Re: Air Quality Permit MD-6042
BART Permit: Naughton Power Plant

Permit No. MD-6042
(BART Permit for the Naughton Plant)

IN THE MATTER OF A PERMIT APPLICATION (AP-6042) FROM PACIFICORP FOR A BEST AVAILABLE RETROFIT TECHNOLOGY (BART) PERMIT FOR THE NAUGHTON POWER PLANT

DECISION

VISIBILITY MODELING RESULTS (Baseline vs. LNB and SCR)

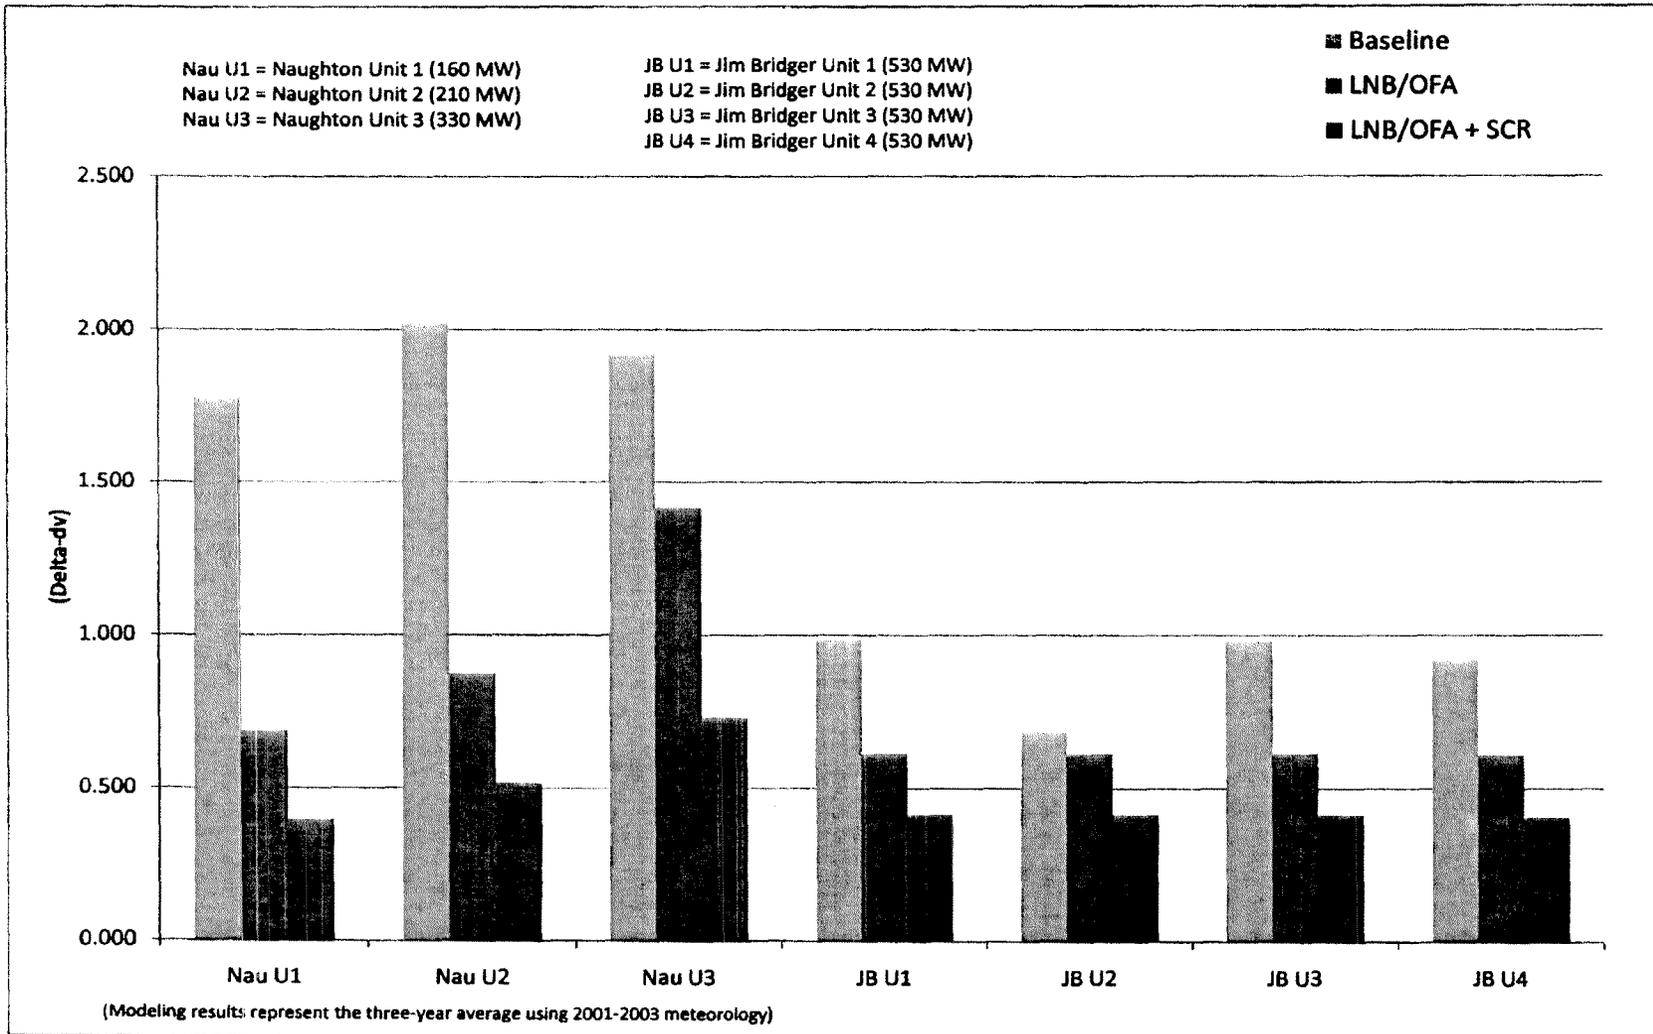
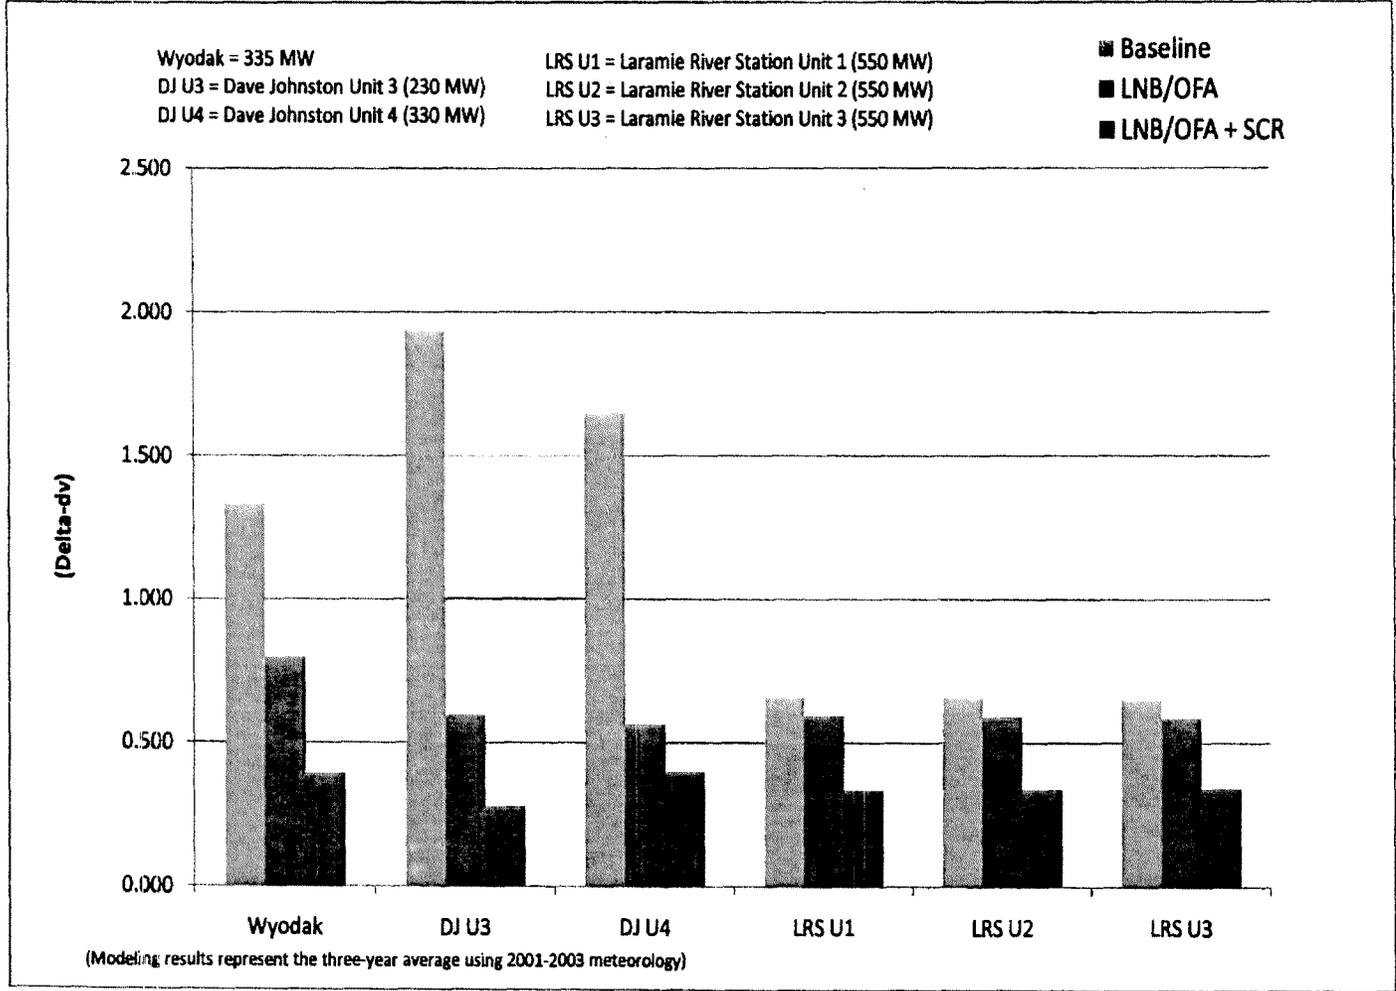
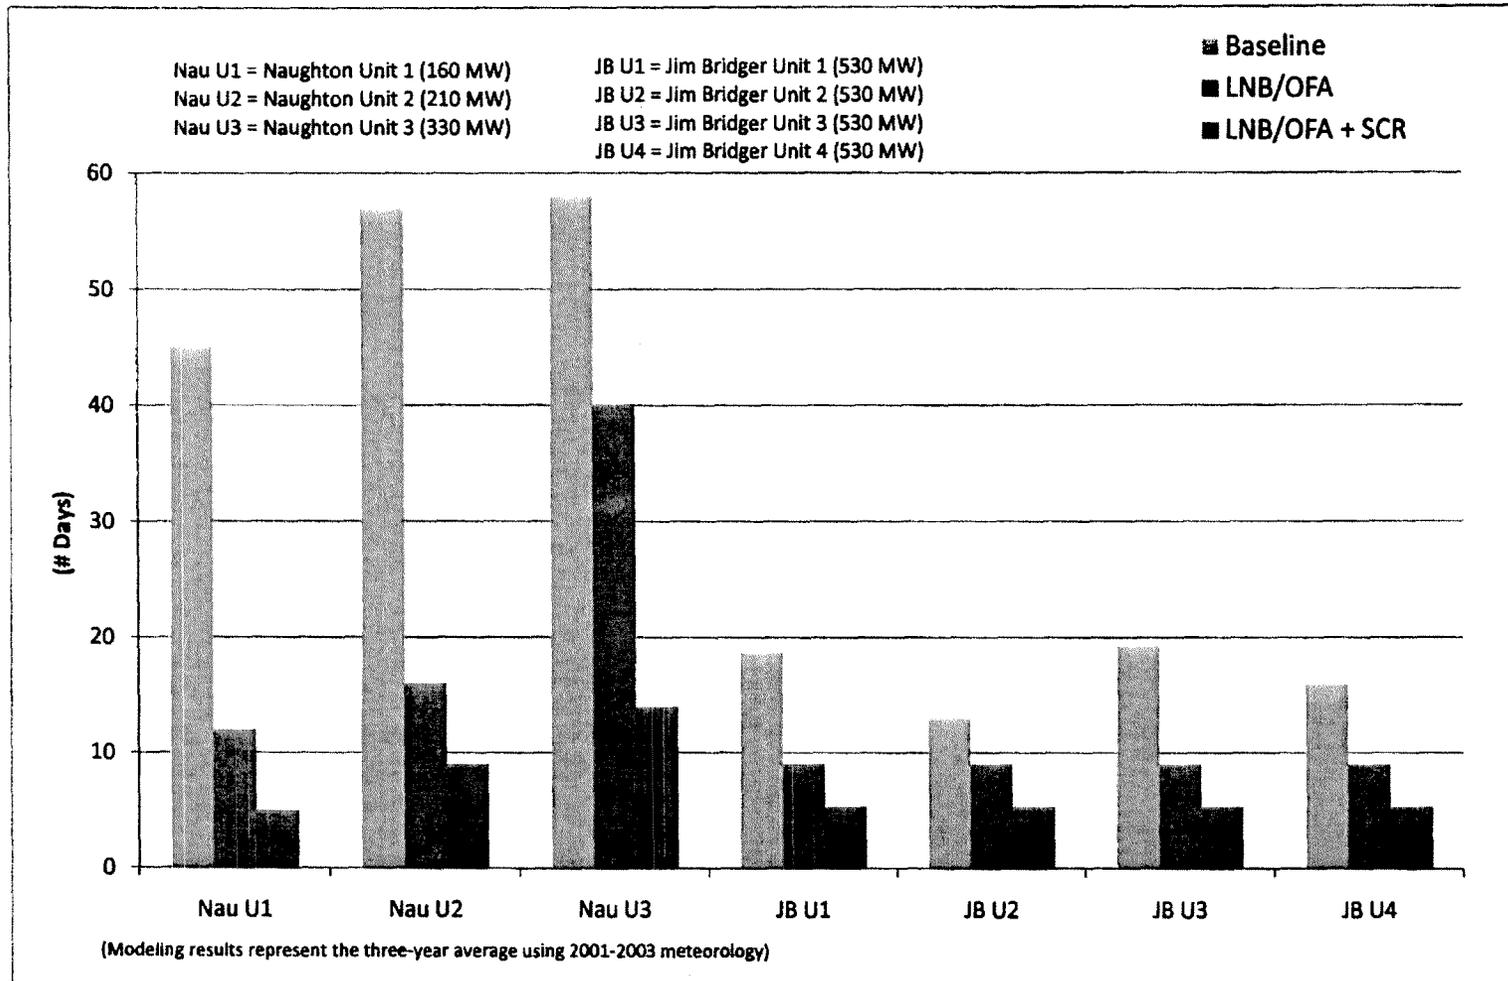
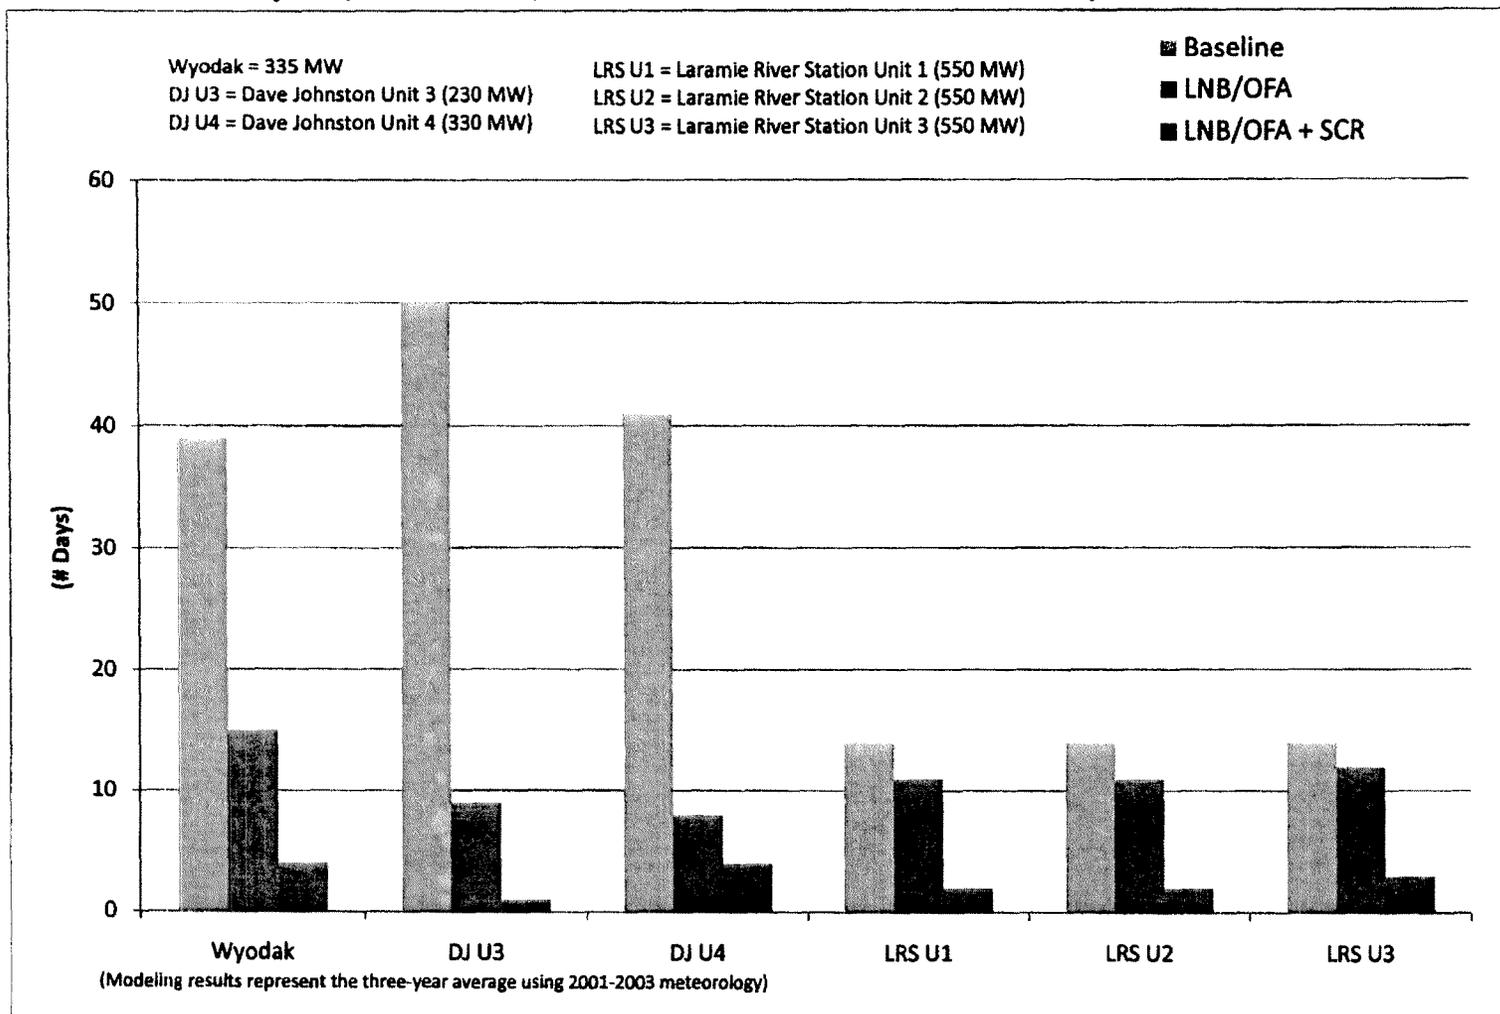
- IV.13 **Boardman, Oregon BART Determination** – PacifiCorp commented that the state of Oregon determined that SCR control was not appropriate for the Boardman Power Plant, yet the cost-benefit values for Boardman are more favorable for SCR installation than for Naughton Unit 3.

Response – The Division determined BART for NO_x control for Naughton Unit 3 based on consideration of all five statutory factors, as required by EPA's Appendix Y BART guidance. The costs for SCR controls, as described in the Division's BART analysis, were deemed by the Division to be reasonable. Modeled visibility reductions from baseline for the LNB/OFA option on Naughton Unit 3 were not nearly as pronounced as they were for other BART-eligible units in the state. The Division determined that SCR would be required on Naughton Unit 3 to bring about additional NO_x emission reductions and additional modeled visibility improvement, and these factors differentiated the Naughton Unit 3 analysis from the others. For additional details, see response to USDA Forest Service comment II.6 and the graphs in Appendix A.
